Document Number	General Development Plan
	Document Title

Project Name: Madison Yards at Hill Farms

City of Madison Site Plan Verification

PROJECT: LNDUSE-2017-00130

FIGURE 12 - FIRE ACCESS DIAGRAM

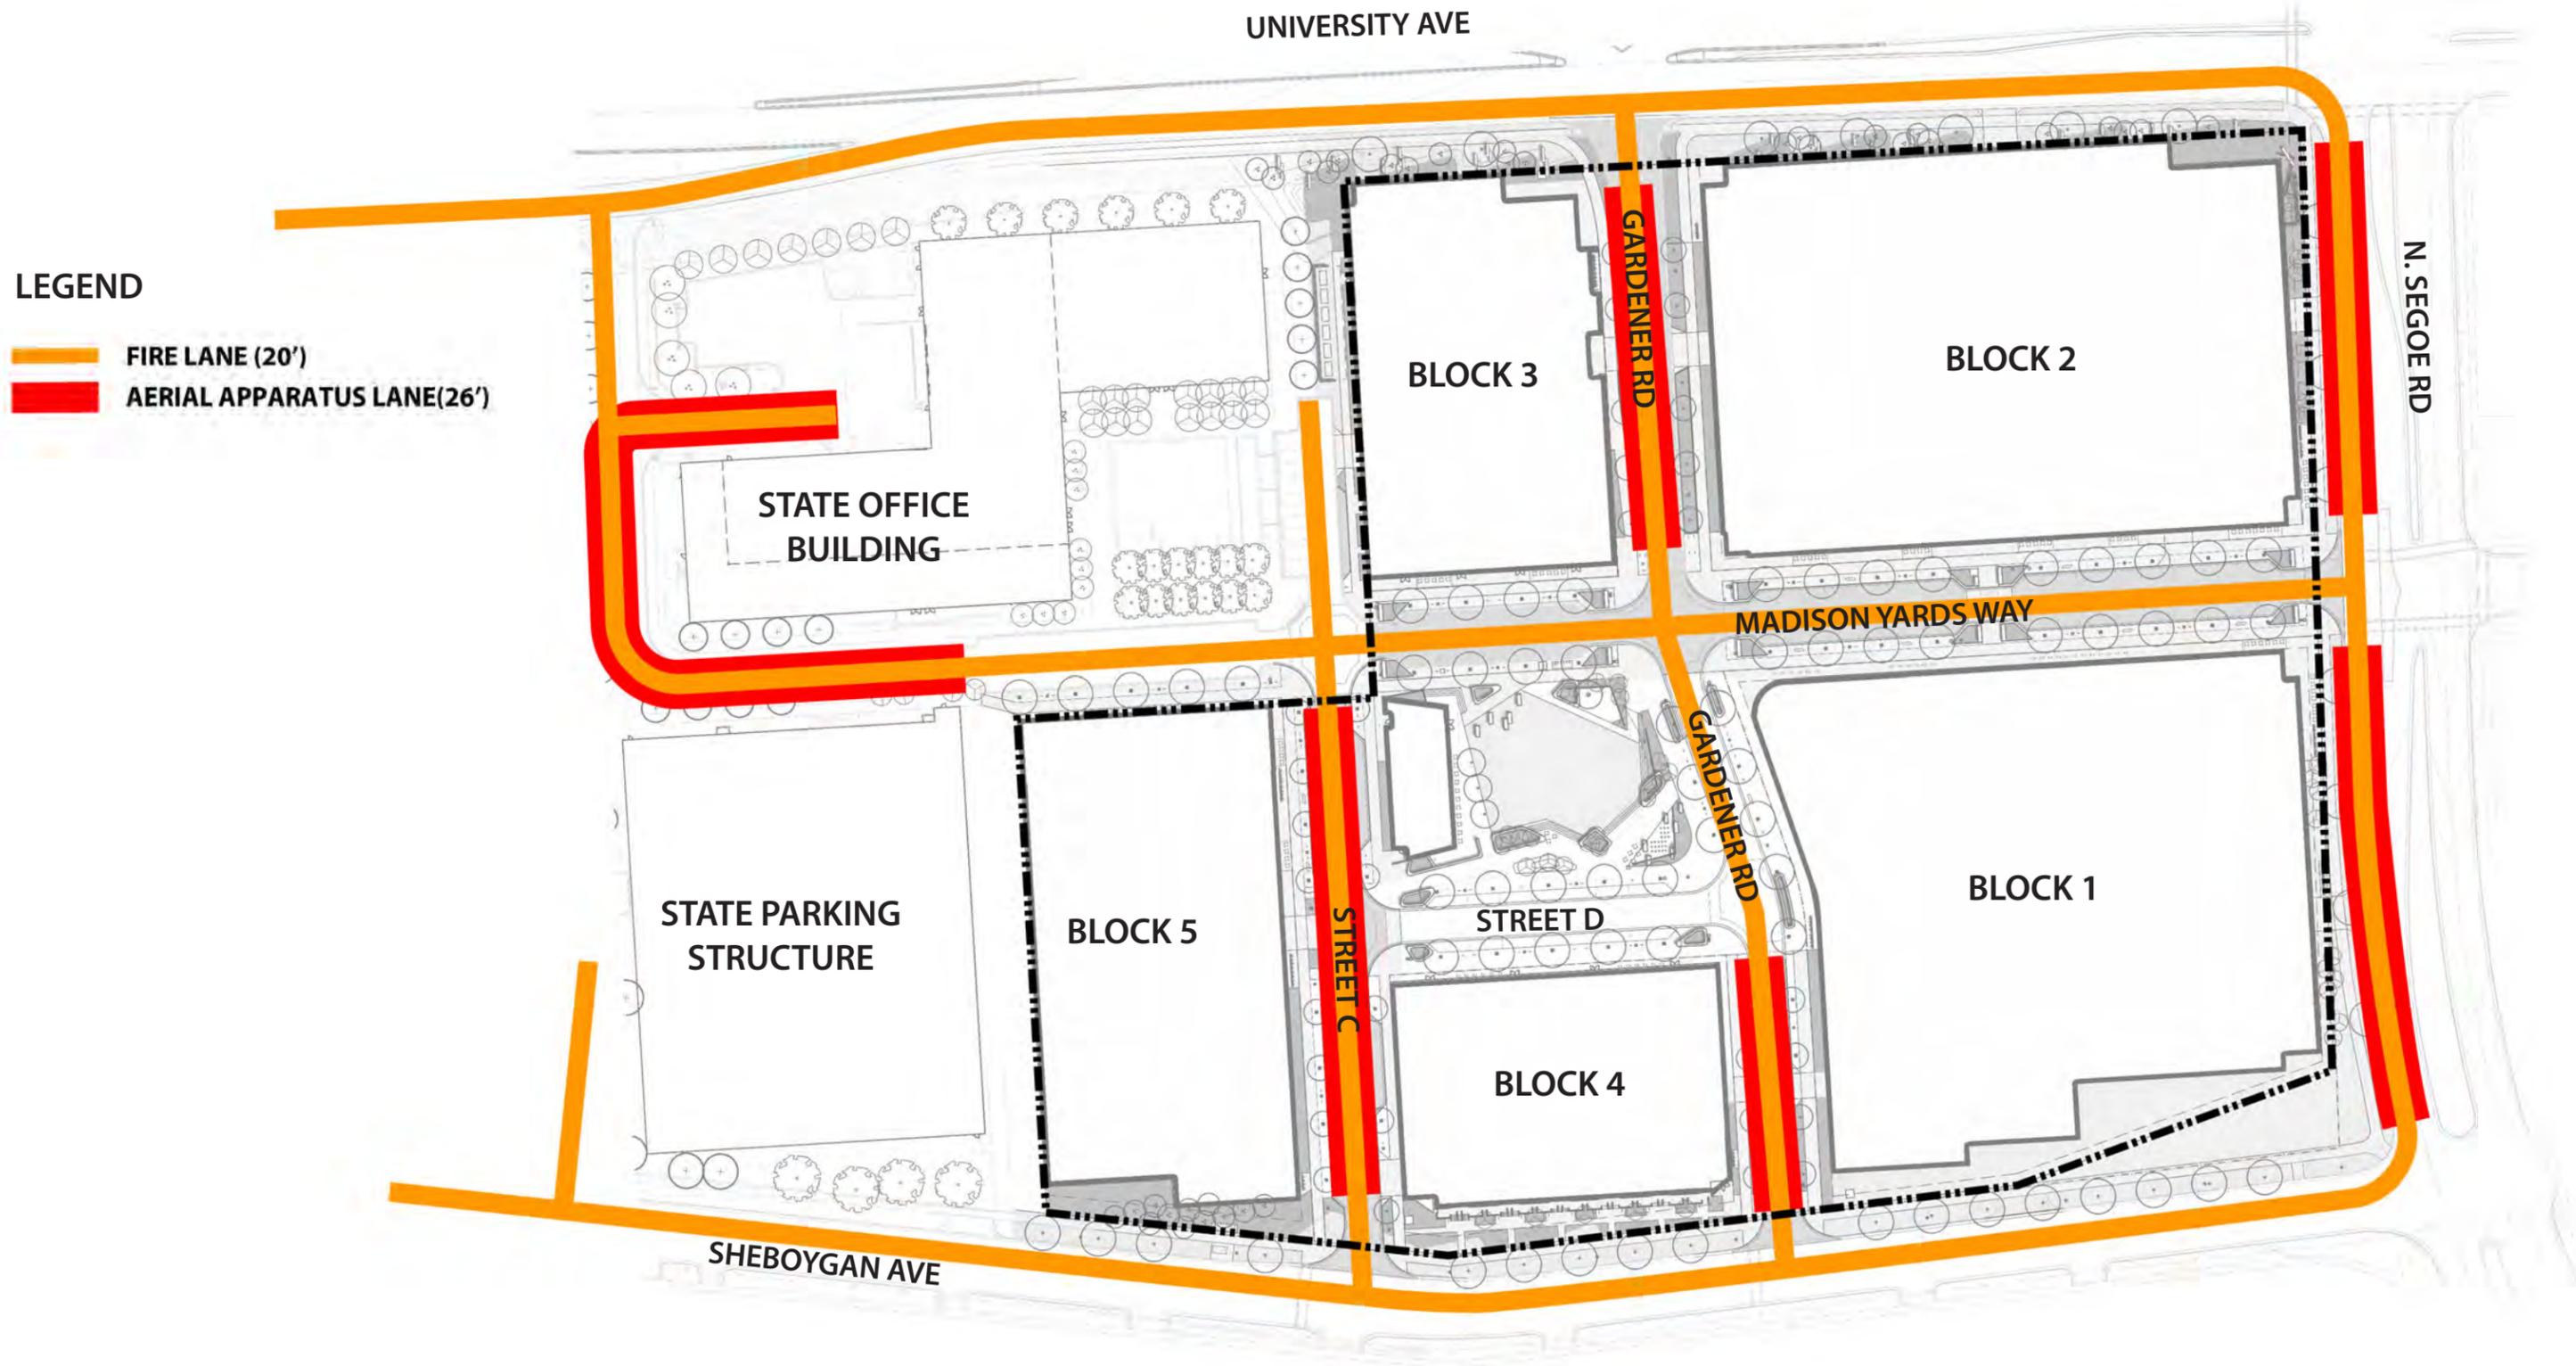
MFD is not opposed to the general development plan. MFD supports the general layout of the proposed fire lanes but may require modifications based on the actual building designs and street scape details.
